Customer	: CU-DAR001 Dart Helicopters Services	Drawing Name	: SHOULDER HARNESS KIT
Job Number	: 29649		
Estimate Number	: 12540		
P.O. Number	: <i>N/A</i>	Part Number	: DSI9351013
This Issue	: 11/22/2006 S.O. No. : <i>N/A</i>	Drawing Number	: DSI9351 REV A
Prsht Rev.	: NC	Project Number	: N/A
First Issue	: <i>N/A</i> Type : SMALL /MED FAB	Drawing Revision	: A
Previous Run	: 29557	Material	: <i>N/A</i>
Written By	: <i>[Signature]</i>	Due Date	: 11/29/2006
Checked & Approved By	: <i>[Signature]</i> 06 11 22	Qty:	<i>3</i> Um: Each
Comment	: Est Rev A New Issue 06-09-27 JLM

DESIGN <i>LE</i>	DRAWN BY <i>LE</i>	DART AEROSPACE LTD HAWKESBURY, ONTARIO, CANADA	
CHECKED <i>GP</i>	APPROVED <i>[Signature]</i>	DRAWING NO. DSI 9351	REV. A SHEET 1 OF 1
DATE 06.09.15		TITLE SHOULDER HARNESS KIT SCALE NTS	
REV A	DATE 06.09.15	DESCRIPTION NEW ISSUE

DART SERVICE INSTRUCTION
TO AMEND INSTALLATION INSTRUCTIONS IIN-D412-702 REV A, B OR C
REF. CANADIAN STC SH04-7
REF. FAA STC SR01997NY

FIGURE 1. KIT INSTALLATION ON CENTRAL PANEL

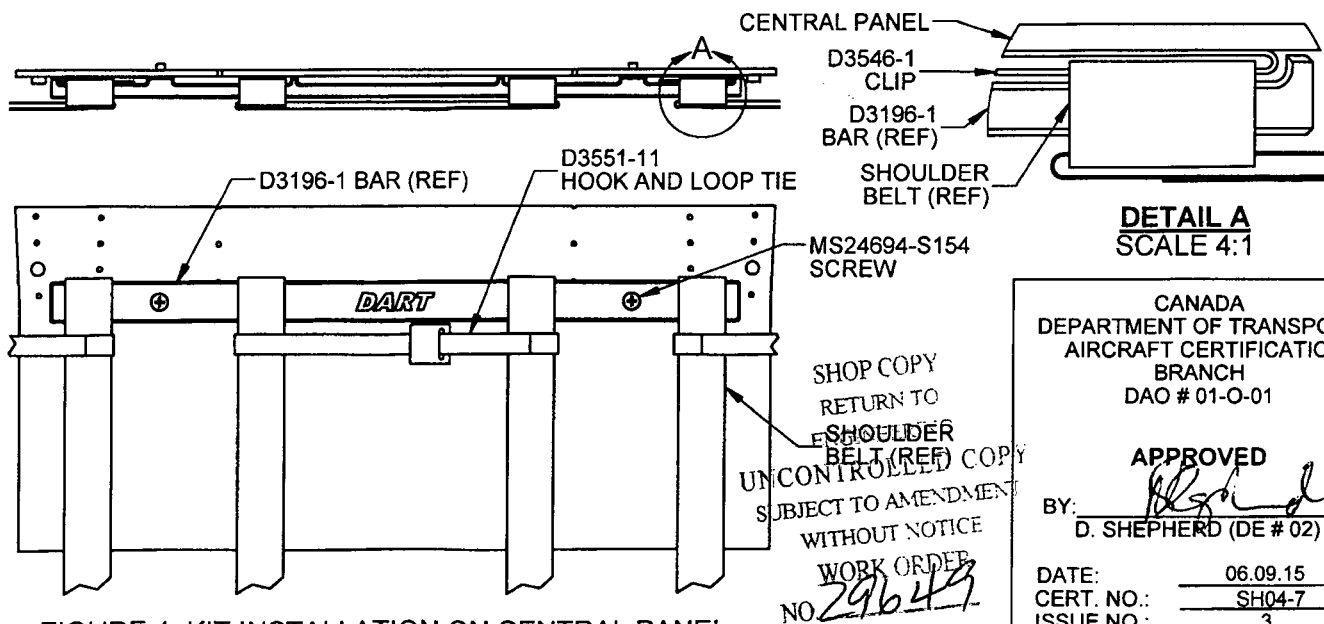
TO IMPROVE THE FIT AND VISUAL IDENTIFICATION OF SHOULDER HARNESS SETS, DSI 9351-011/-013/-015 SHOULDER HARNESS UPGRADE KITS ARE AVAILABLE FOR THE D412-702-011/-021/-013/-023/-015/-025/-017/-027 AND D214-702-035 SHOULDER HARNESS KITS AT CHANGE 1. INSTALLATION OF THESE KITS IS OPTIONAL.

- 1) REMOVE THE MS24694-S152 SCREWS FROM THE D3196-1 BAR ON THE CENTRAL PANEL. RE-INSTALL THE D3196-1 BAR WITH D3546-1 CLIPS USING MS24694-S154 SCREWS AS SHOWN IN FIGURE 1. ENSURE THAT THE SHOULDER BELTS ARE LOOPED THROUGH THE CLIP AS SHOWN IN DETAIL 'A'. TORQUE SCREWS TO 100-140 in-lbs (11.3-15.8 N-m). IT IS ACCEPTABLE TO USE LONGER MS24694-SXXX SCREWS AS REQUIRED TO ENSURE THAT THE D3196-1 BAR IS PROPERLY SECURED.
- 2) INSTALL THE D3551-11 HOOK AND LOOP TIES THROUGH THE FRONT LOOPS OF EACH SET OF SHOULDER BELTS. INSTALLATION ON THE 4-MAN AFT FACING BENCH IS AT THE DISCRETION OF THE INSTALLER. ENSURE THAT THE 'LOOP' SIDES OF THE TIES ARE FACING OUTWARD FOR PASSENGER COMFORT. TIGHTEN OR LOOSEN THE TIES AS NEEDED (TRIMMING IS ACCEPTABLE).
